Access Compliance Report

Public Rights-of-Way

(Curb Ramps)

Intersection ID: 16523	Main Street: WALKER_RD	Cross Street: MCALWAY_RD	Location: SW
ADA ID: 205C23EB5D28	Ramp Type: Perp	Initial Pass/Fail: Fail	Overall Compliance: No
Severity Score: 21.25			
Codes/Mitigation Info/Possible Solution		Field Measurements/Component Compliance

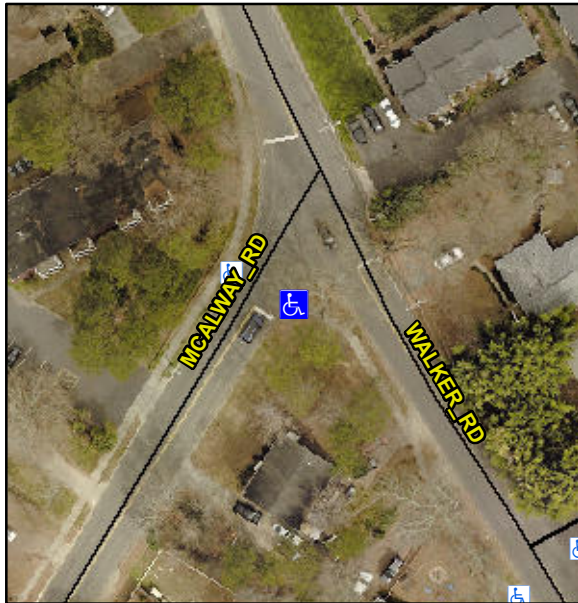
Not Found, R304.5.1, R304.2.2

Compliance	Description	Data	Compliance	Description	Data
N/A	Ramp Length (in)	65.0	No	Ramp Slope (%)	9.4
No	Ramp Width (in)	47.5	Yes	Ramp XSlope (%)	1.4
N/A	Flare Type LT	N/A	N/A	Flare Type RT	N/A
N/A	Flare Slope LT (%)	N/A	N/A	Flare Slope RT (%)	N/A
N/A	Flare Traversable LT?	N/A	N/A	Flare Traversable RT?	N/A
N/A	Landing Length (in)	N/A	N/A	DWS Provided?	N/A
N/A	Landing Width (in)	N/A	N/A	DWS Contrast?	N/A
N/A	Landing Slope (%)	N/A	N/A	DWS Length (in)	N/A
N/A	Landing X Slope (%)	N/A	N/A	DWS Full Width?	N/A
N/A	Landing Curb? (Y/N)	N/A	N/A	DWS Offset (in)	N/A
N/A	Shared Landing?	N/A			
N/A	Gutter Ponding?	N/A	N/A	Gutter Slope (%)	N/A
N/A	Gutter Lip Ht (in)	N/A	N/A	Gutter X Slope (%)	N/A
N/A	Painted X Walk1?	No	N/A	Painted X Walk2?	N/A
	X Walk 1 Direction	To NW		X Walk 2 Direction	N/A
N/A	X Walk 1 Width (in)	N/A	N/A	X Walk 2 Width (in)	N/A
	X Walk 1 Slope (%)	5.5		X Walk 2 Slope (%)	N/A
	X Walk 1 X Slope (%)	0.0		X Walk 2 X Slope (%)	N/A

Remove & Replace Entire Ramp.
